# Response to Representations – St Lukes DA 0486/2021

89-93 CIMITIERE STREET

SUN STUDY COMPARISON

ST. LUKES HEALTH

PERMITTED  
DECEMBER 21 - 9 AM

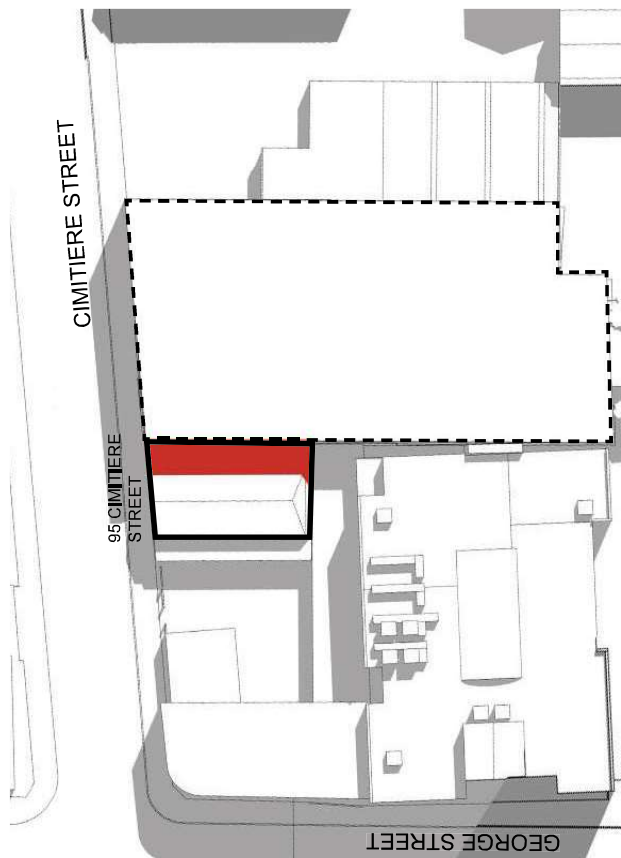
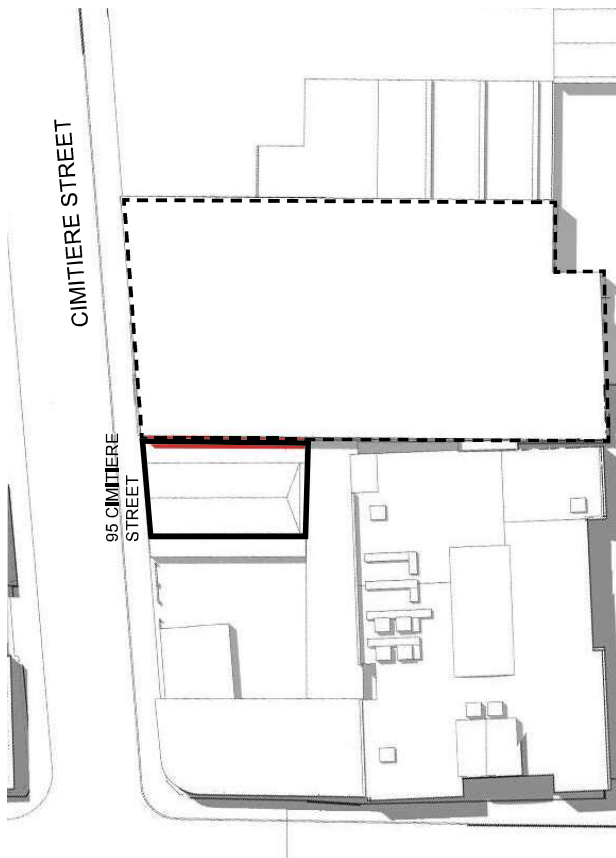
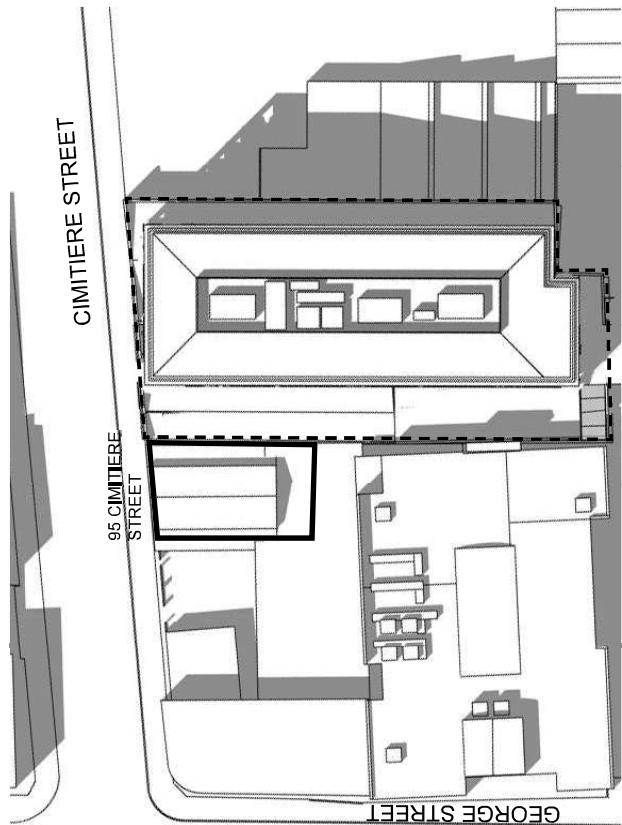
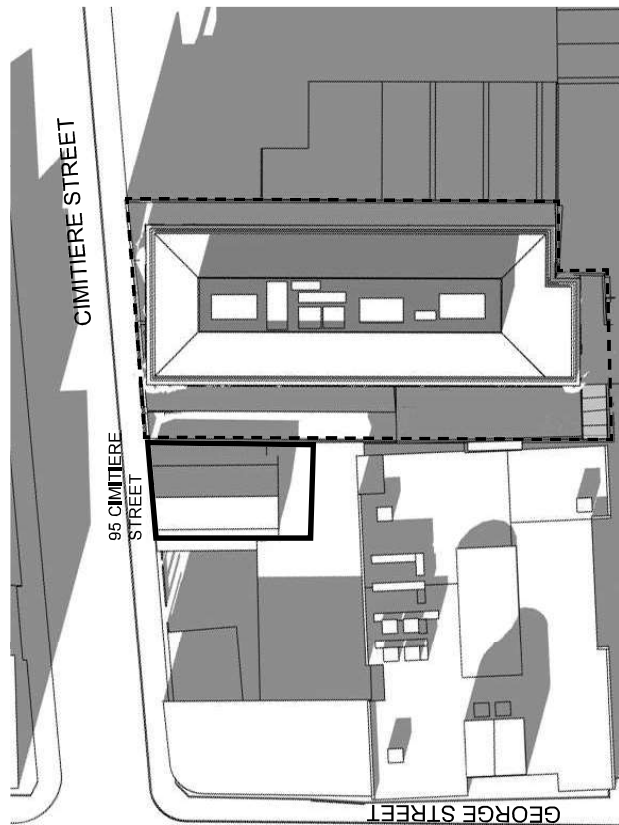
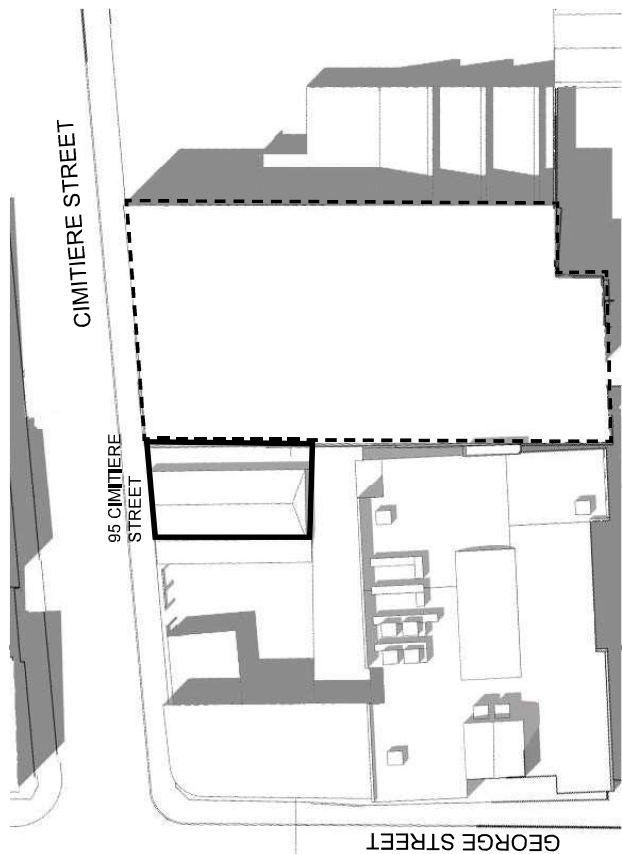
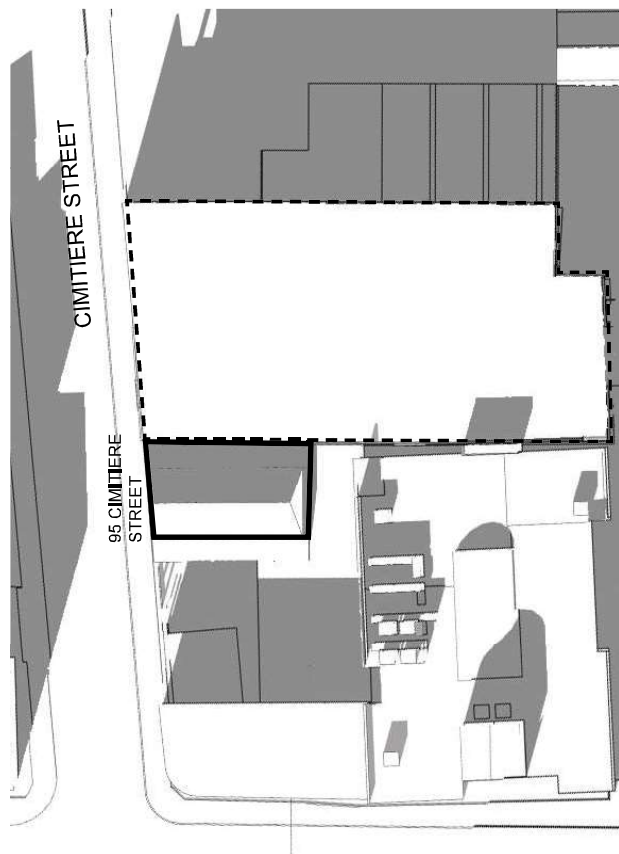
| <p>Representor owns adjoining property to the west. Concerned that the proposed building height will render the representors solar panel installation virtually useless during most of the day</p> | <p>considered for its value in shading the upper two level's facades and providing a visually attractive roof garden to Level 6.</p> <p>Additional shadow studies (copy attached) have been provided for 21st June, 21<sup>st</sup> September and 21<sup>st</sup> December to compare the proposed building and a building constructed to the permitted building envelope under the zone i.e 12m high and built to the side boundaries.. The sun studies show that the overshadowing is equal and, at times, is reduced to that of a permitted height building due to the set back of the west elevation. An increased shadowing of the proposed building to the permitted building only occurs at 9am between September and December.</p> |

| <p>Representor has plans to construct an upper level apartment on their building. The amenity and lack of privacy of this future apartment will be impacted by the proposed building.</p>          | <p>As per comments above, the orientation of the building to the street means solar access is maintained to adjacent properties for morning or afternoon periods.</p>  |
